URGENT Voluntary Medical Device Correction **HeartStart MRx**

Therapy Cable Connection Wear May Lead to a Malfunction in Detection of Defibrillation Pads/Paddles Therapy Cables

Emergency Care Solutions -2/4- FSN86100113A **2012 June**

HeartStart MRx Instructions for Use Addendum

Figure 4 Stabilizer Lid

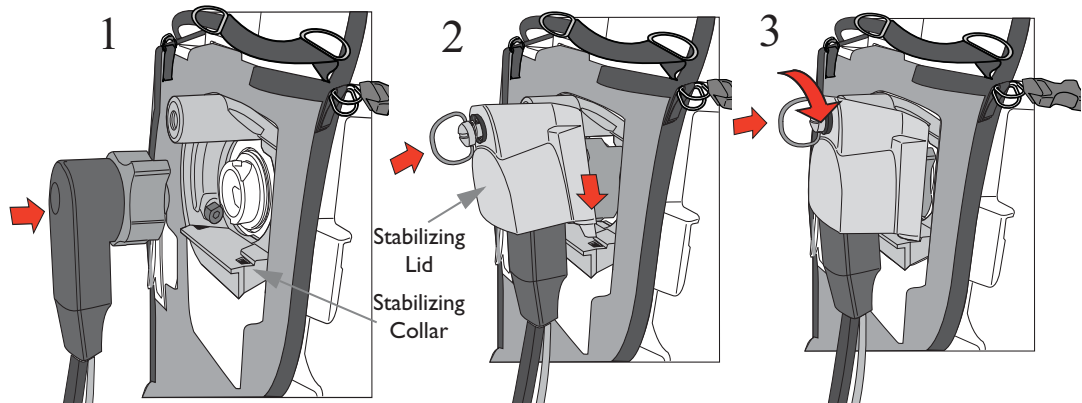
- 1 Plug the Therapy Cable into the green connector port (Figure 4 - Step 1)
- 2 Place the Stabilizing Lid over the Therapy Cable. Slide the lid hooks into the holes on the lower lip of the base. Then push the lid into place. (Figure 4 - Step 2)
- 3 Press the lid latch in and turn to the right to lock into place (Figure 4 - Step 3)

- 4 To remove the cover, lift up on the lid latch and turn to the left. After the screw disengages, lift the lid out of place. You can also use a flat-head screwdriver to engage and disengage the cover.
